**Staff Report**

**Date:** June 4, 2020  
**To:** Advisory Design Review Group  
**From:** Matthew Weintraub, Planner  
**Subject:** 1 Upper Road

The applicant is requesting approval of a Design Review Amendment to revise a previously approved project to add a new box dormer to the east elevation of the main house, and to modify the trash enclosure and wall along Upper Road. A Design Review was required for the previously approved project.

1 Proposed Second Floor Plan  
SCALE: 1/4" = 1'-0"

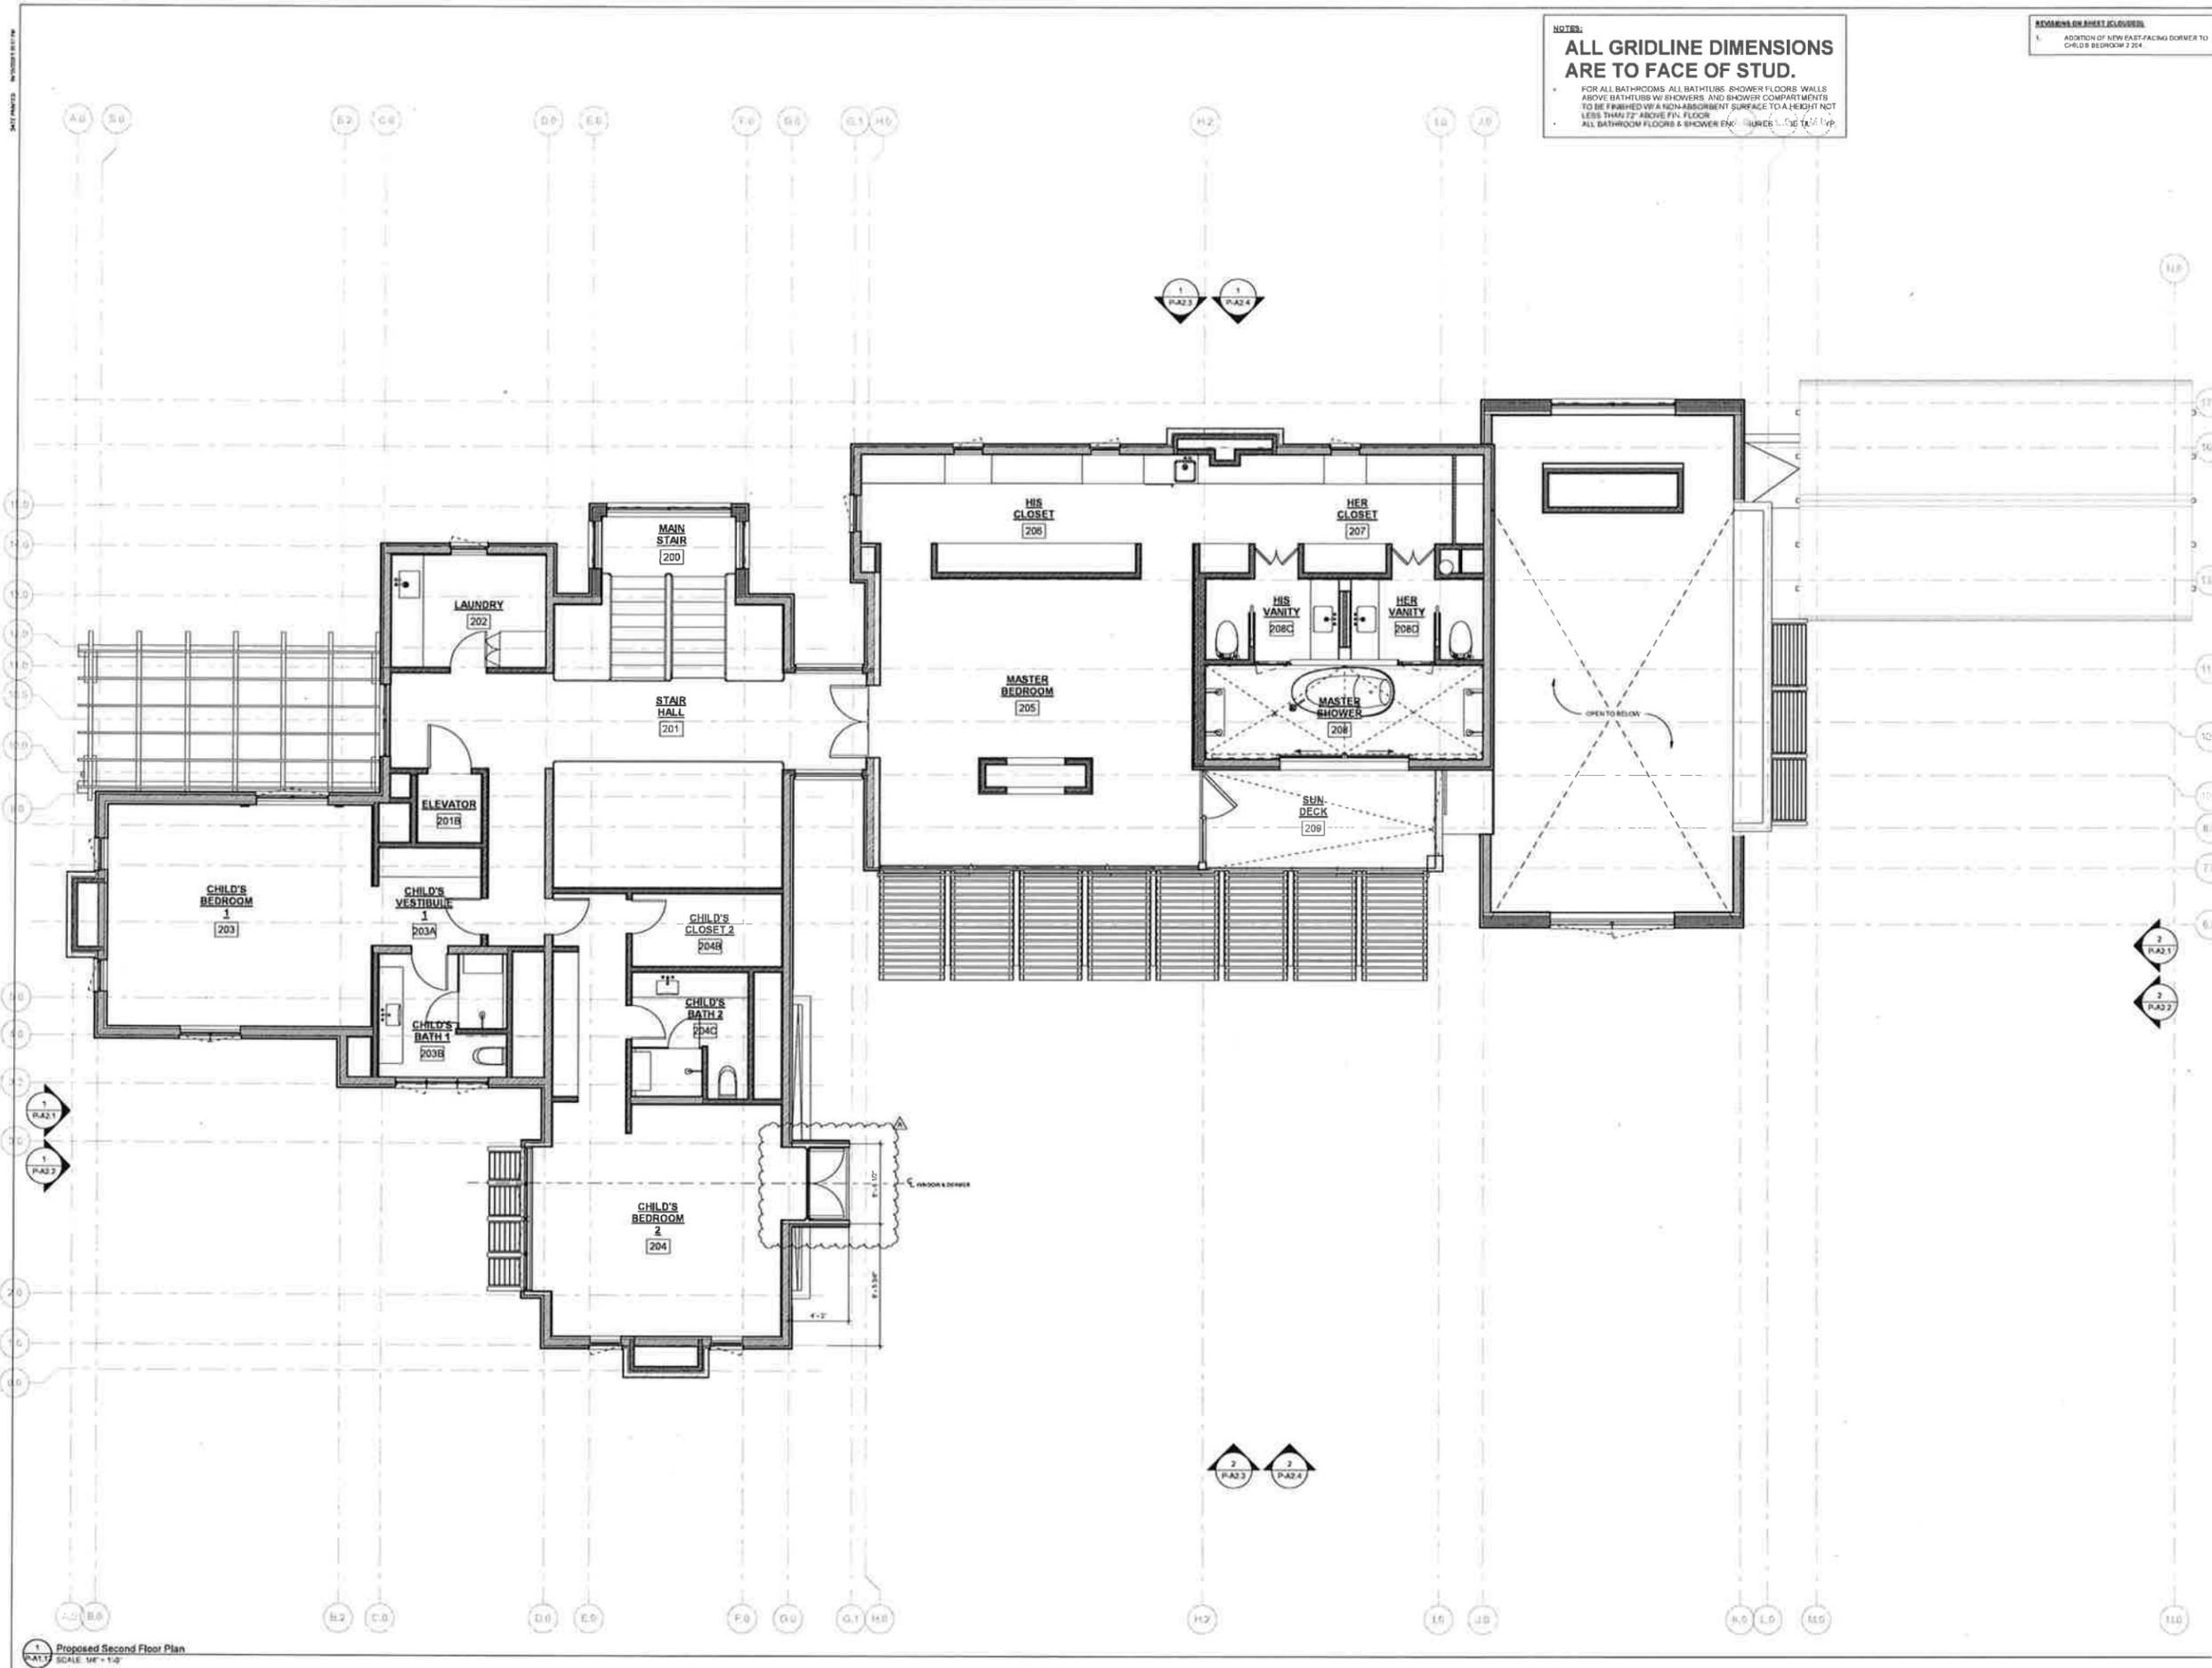
**MAIN HOUSE:** ADDITION OF EAST-FACING DORMER TO CHILD'S BEDROOM 2 ROOF VOLUME OVERLOOKING THE POOL, MATERIAL TO MATCH APPROVED MATERIALS.

ORIGINAL SHEET DATE: 03/23/20  
SCALE: 1/4" = 1'-0"  
DRAWN BY: AMA  
SHEET NUMBER: P-A1.14

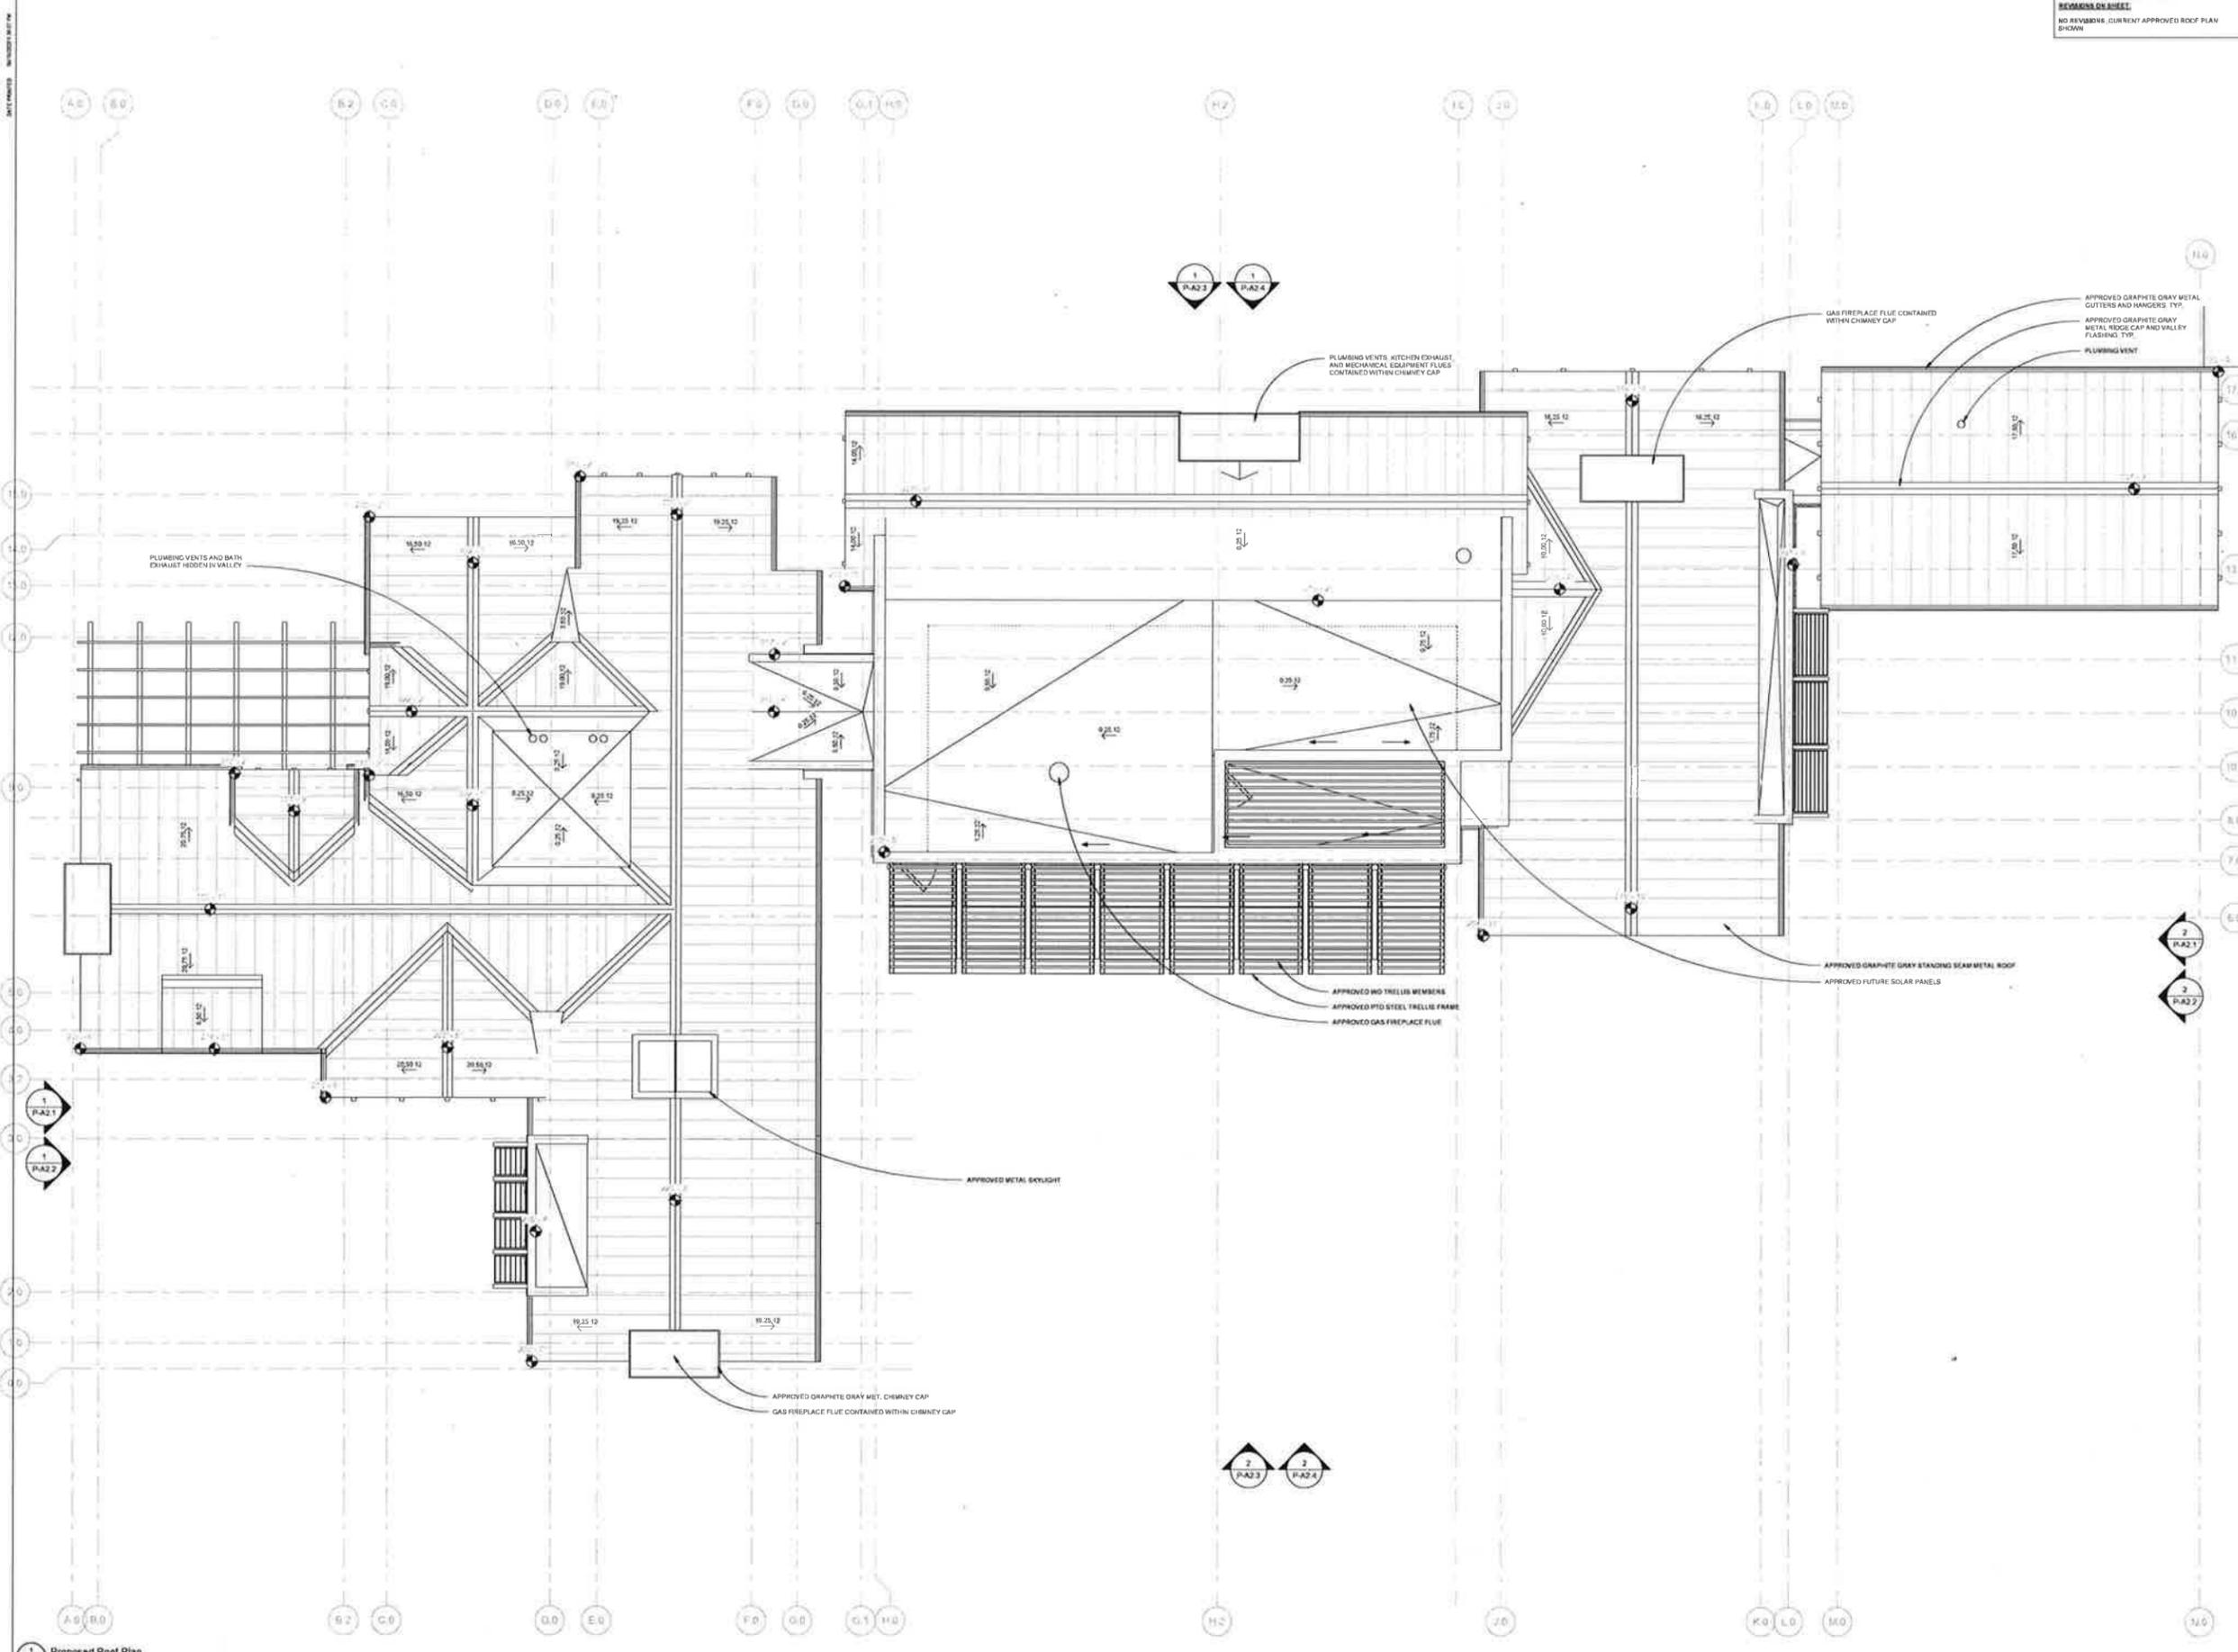
REVISIONS TO SHEET PLUMBING  
 6. ADDITION OF NEW GAS-FACING CORNER TO CHILD'S BEDROOM 2204

SHEET TITLE  
MAIN HOUSE - APPROVED & PROPOSED AERIAL NW VIEWS

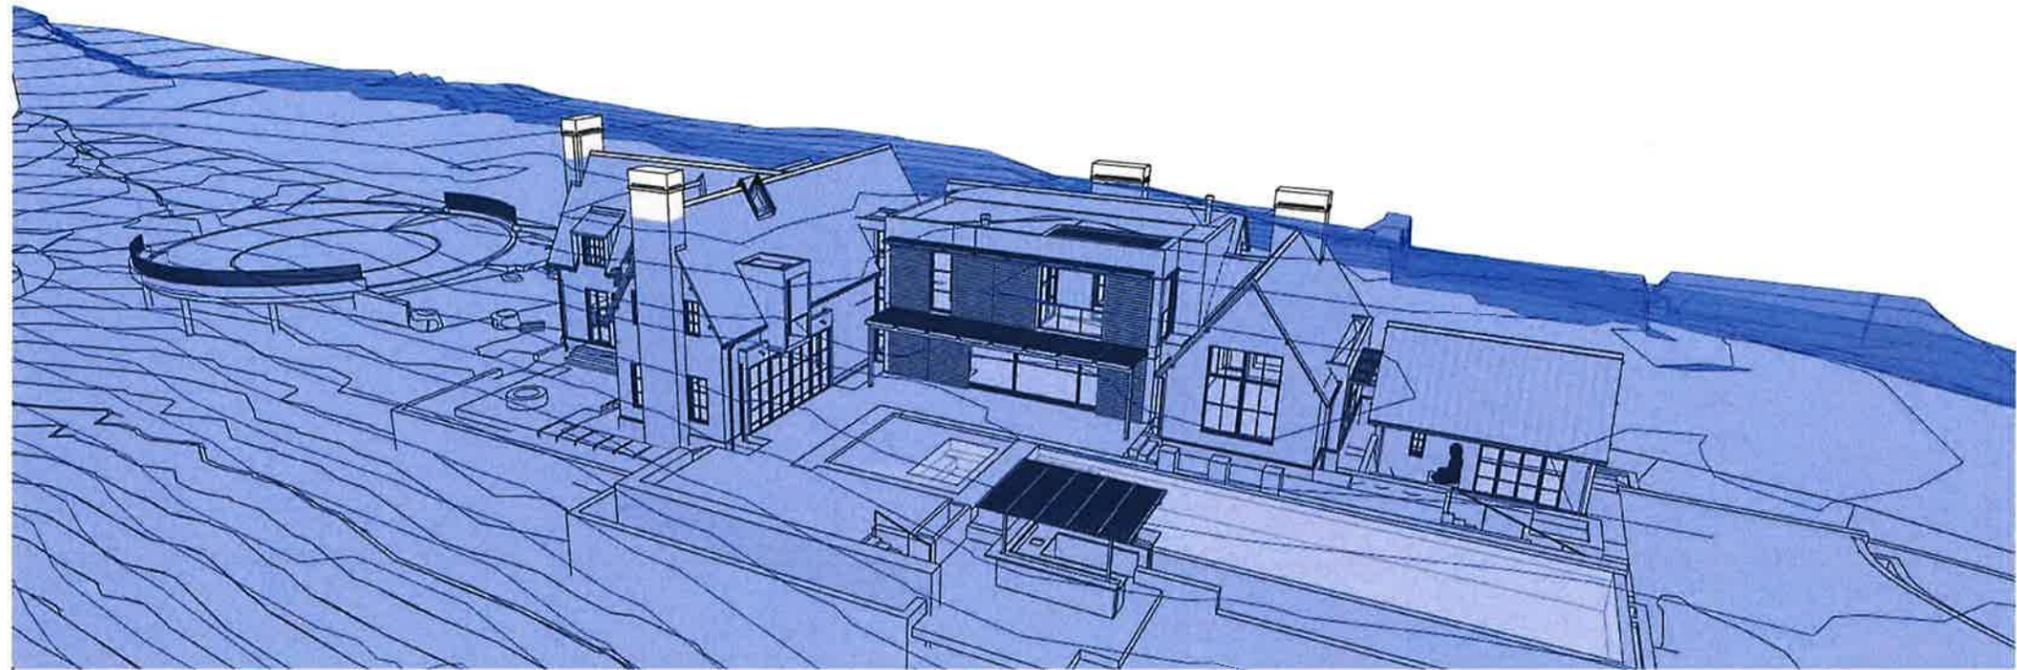
- The proposed revision to the main house is the addition of a new East-facing dormer to provide increased light and air to Child's Bedroom #2.
  - The design for this dormer is in keeping with the language of the approved design.
